Docket 50-305
 Operating License DPR-43
 Kewaunee Nuclear Power Plant
**Additional Information for Proposed Amendment 164 to the Kewaunee Nuclear Power Plant
 Technical Specifications: Extension of Use Through Cycle 24 of the Length Based Pressure
 Boundary Definition for Westinghouse Steam Generator Hybrid Expansion Joint Sleeved Tubes**

NRC RAI

Figure 1

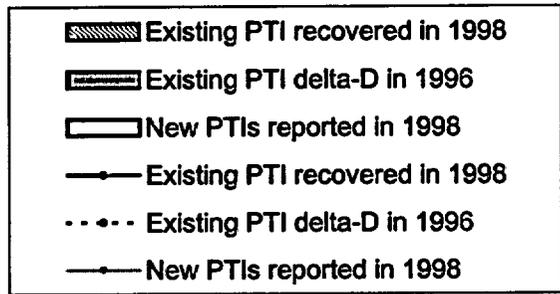
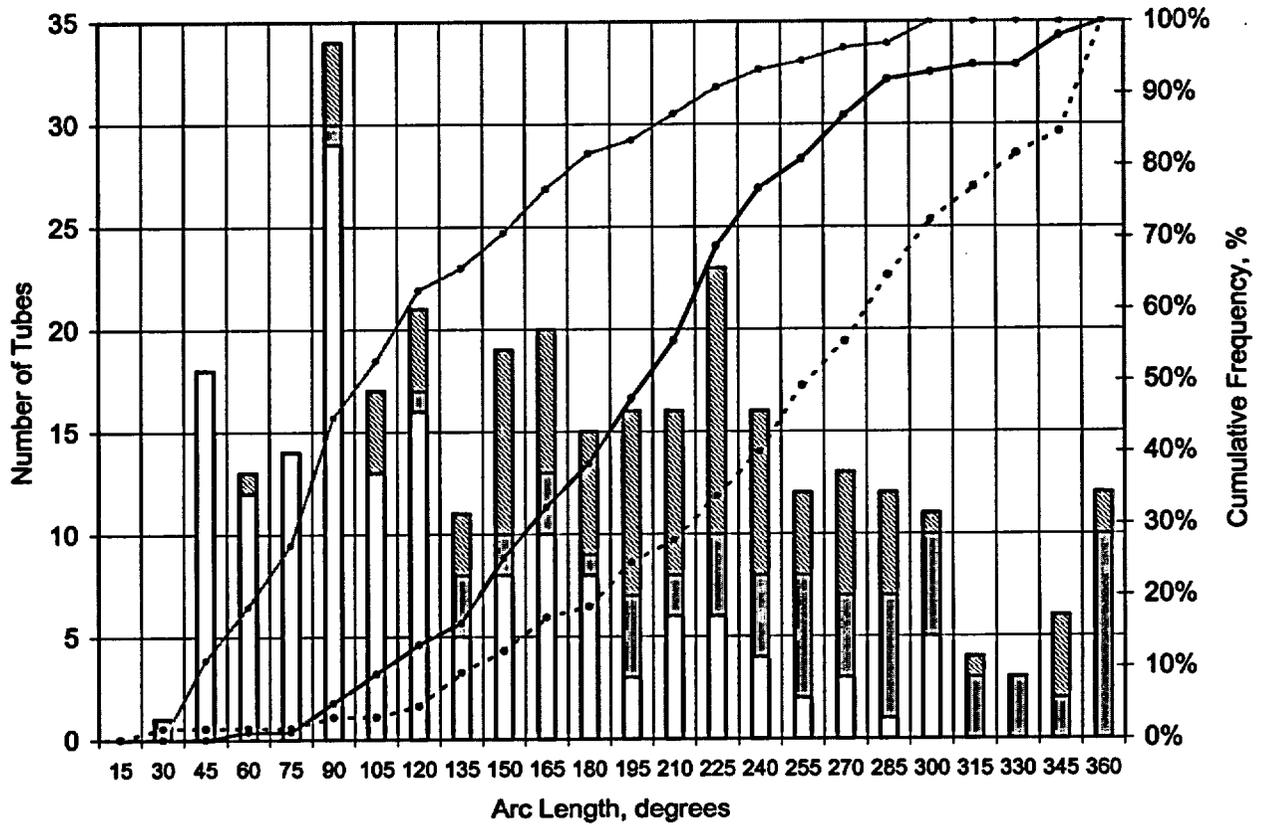
Provide a frequency distribution of the extent (arc length) of circumferential PTIs in the hybrid expansion joints from previous inspections.

Table 1 provides the mean reported arc length, largest reported arc length, number reported during the 1998 RFO, and number currently in service for cycle 23 for each population of PTIs. The frequency distribution of PTIs from the 1998 inspection is provided in Figure 1 for SG A and Figure 2 for SG B.

Figure 3

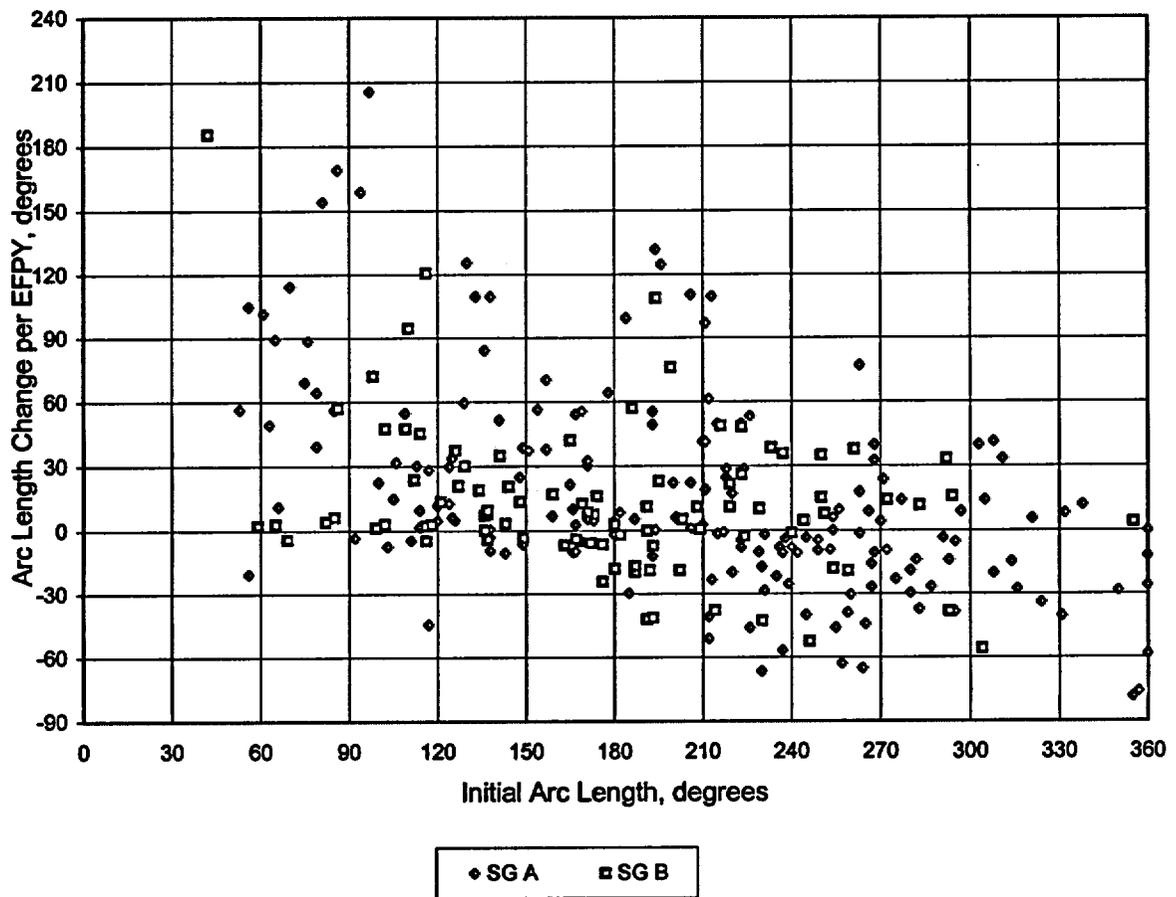
Provide an analysis of the circumferential PTI growth rate based on previous inspection data.

A total of 262 tubes are contained within these two populations. Arc lengths from the 1996 and 1995 inspection data were measured consistent with the methodology used in measuring arc lengths from the 1998 inspection data. Changes in arc lengths between the 1998 RFO and either the 1996 RFO or 1995 RFO were normalized in terms of arc length change per effective full power year (EFPY). A scatter plot showing the change in arc length per EFPY as a function of the initial PTI arc length is shown in Figure 3. The mean growth rate per EFPY is calculated in 30 degree bins, treating the negative arc length differences shown in Figure 3 as zero. The results are shown in Table 2. Similar growth rates were observed for both SGs, with higher growth rates per EFPY observed for the smaller arc lengths.

Figure 6
 Steam Generator A
 EOC 24 Distribution of PTIs

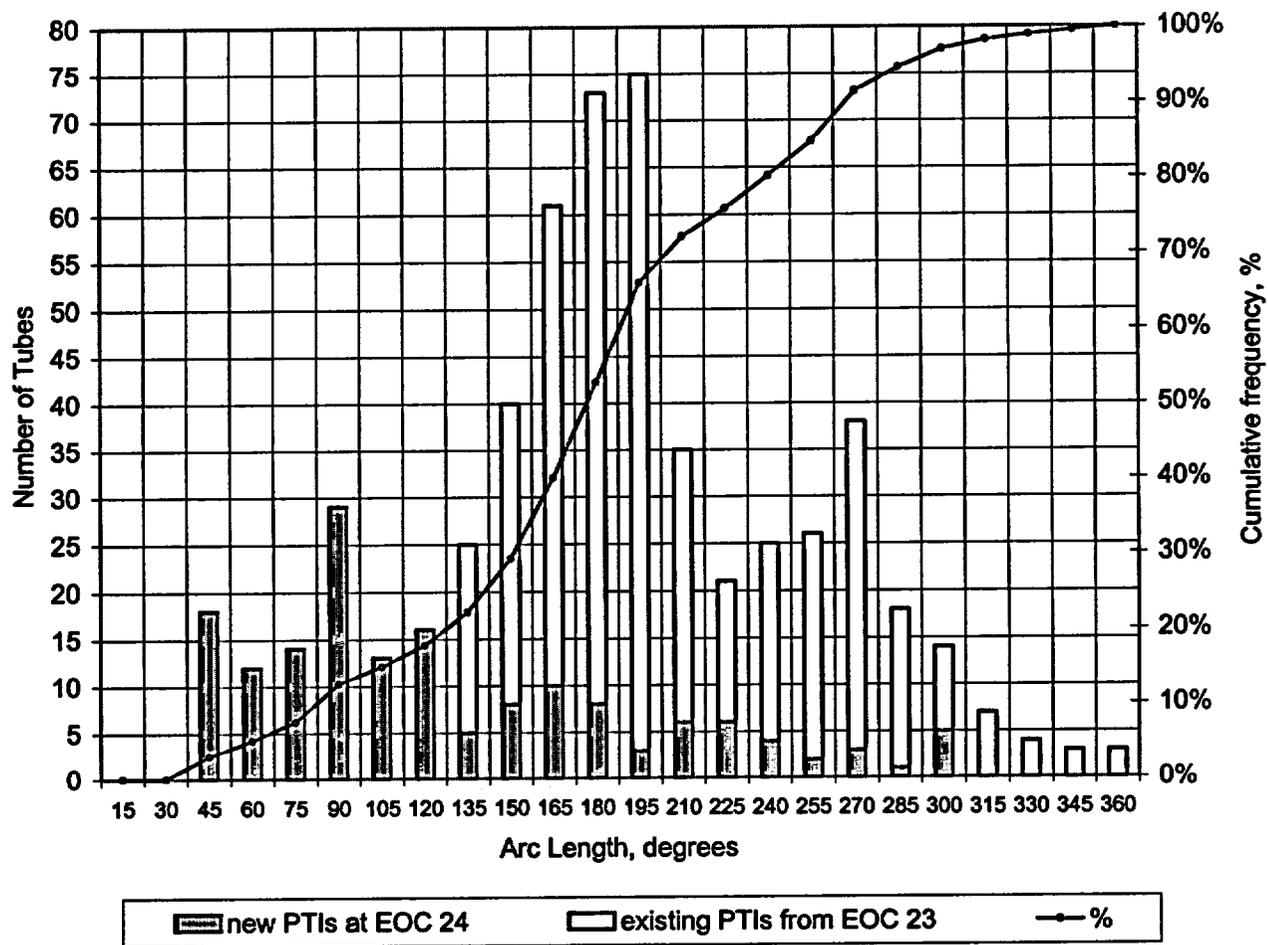
Given the PTI growth rate, demonstrate that all tubes having circumferential PTIs satisfy the safety margins in Regulatory Guide at the end of cycle 24. If tubes with circumferential PTIs do not satisfy the safety margins in Regulatory Guide 1.121, provide a criterion (limit) for the growth of the circumferential PTIs such that the degraded tubes at the end of cycle 24 will satisfy the safety margins in Regulatory Guide 1.121. Tubes having circumferential PTIs that do not satisfy the growth criterion (limit) would need to be plugged.

EOC 24 corresponds to the September 2001 RFO, in which SG replacement is planned. The EOC 24 population of PTIs consists of two subgroups: 1) PTIs left in service which met the L criterion during the 2000 RFO, and 2) new indications previously undetected during the 2000 RFO. For those PTIs left in service following the 2000 RFO, i.e., at the beginning of cycle (BOC) 24, the mean arc length increase reported in Table 1, at the corresponding initial arc length bin, is added to the BOC 24 arc length in order to project an EOC 24 arc length. The arc length increase reported in Table 1 is adjusted for the expected cycle 24 EFPY. The distribution of new indications expected at EOC 24 is assumed to be identical to the distribution of new indications reported during the 1998 RFO (i.e., at EOC 22). Figure 6 shows the postulated EOC 24 distribution of PTIs for SG A, and Figure 7 shows the postulated EOC 24 distribution of PTIs for SG B.
